**Federal Highway
Administration**

In Reply Refer To:
HSST-1/CC-126C

- MSKT- SP-MGS (MASH Sequential Kinking Terminal, Standard Posts, Midwest Guardrail System) with Wood Posts.

Wood-Post MSKT System Product Description

MSKT-MGS-W
Terminal
Test Level 3

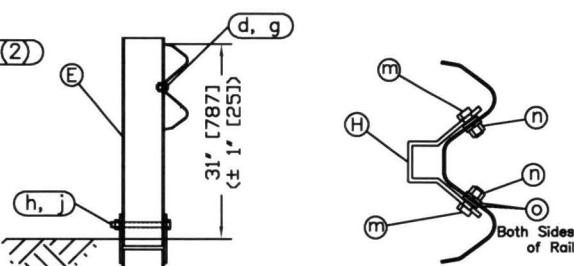
Figure 1 shows a schematic drawing of the wood-post MSKT terminal. The wood-post system uses the same SP anchorage system, i.e., the same steel posts 1 and 2 with a ground strut, as the steel-post system. Posts 3 through 8 are CRT (Controlled Release Terminal) wood posts, and standard wood line posts are used from post 9 and beyond. Other than the posts, the other components of both MSKT systems are the same.

For head-on impacts (Test Designation 30, 31, 32, and 33), both steel-post and wood-post systems should perform the same from the initial point of impact up to post 3 since both systems use the same steel Posts 1 and 2 with a ground strut anchorage system. From Post 3 through Post 8, the wood-post system is, in our opinion, more consistent and predictable than the steel-post system. The wooden CRT posts are designed to break away at a given force level when impacted in a longitudinal direction. In comparison, the standard steel line posts are simply pushed down when impacted in a longitudinal direction to allow for vehicle to pass over the bent posts. Thus, there is more debris on the ground in the path of the vehicle for the steel-post system, which could potentially cause the vehicle to roll and yaw. Thus, we believe that the wood-post system would perform in a more consistent and predictable manner than the steel-post system for head-on and shallow angle impacts.

For redirection impacts (Test Designation 34 and 35), both steel-post and wood-post systems use the same anchorage system, so the anchorage capacity for both systems would be similar. Thus, any difference in the performance of the two systems in redirection impacts would be in the lateral resistance of the posts and the interactions between the posts and the rail. The lateral resistance of wood and steel posts have been found to be fairly comparable in various studies over the years based on dynamic testing results. For example, in a recent study by Midwest Roadside Safety Facility ⁽¹⁾, a series of bogie tests were conducted on wood and steel posts and the researchers concluded that "*standard steel posts would also provide similar post-soil resistance to 6-in x 8-in. (152-mm x 203-mm) wood posts when installed in level terrain and using 6-ft (1.8-m) long sections.*" In terms of interactions between the posts and the rail, the wood posts also perform better. Steel posts tend to bend and twist while breakaway wood CRT posts would break and split. There is also a potential for the rail to contact the edge or corner of the steel post flanges, resulting in a tear and even rupture to the rail. This would not be a problem for the wood-post system since the wood posts do not present any sharp edges. Also, wheel snagging may be more of a concern for steel-post systems given the bending and twisting of the posts. The satisfactory performance of wood-post guardrail systems in redirection impacts (Tests 3-10 and 3-11) under MASH guidelines was demonstrated in two series of crash tests conducted on the Midwest Guardrail System (MGS) with Southern yellow pine wood posts and white pine wood posts. ^(2, 3)

For the reverse direction impact (Test Designation 37), there should not be any difference between the wood-post and steel-post systems, given the point of impact and that Posts 1 and 2 and the ground strut are the same for both systems.

In summary, we believe that the steel-post system is actually more critical than the wood-post system for reasons explained above. Since the MSKT steel-post system successfully passed all MASH evaluation criteria, it is our opinion that the MSKT wood-post system would also satisfy all of the MASH requirements with no problem. Thus, it is requested that the wood-post MSKT terminal be approved.
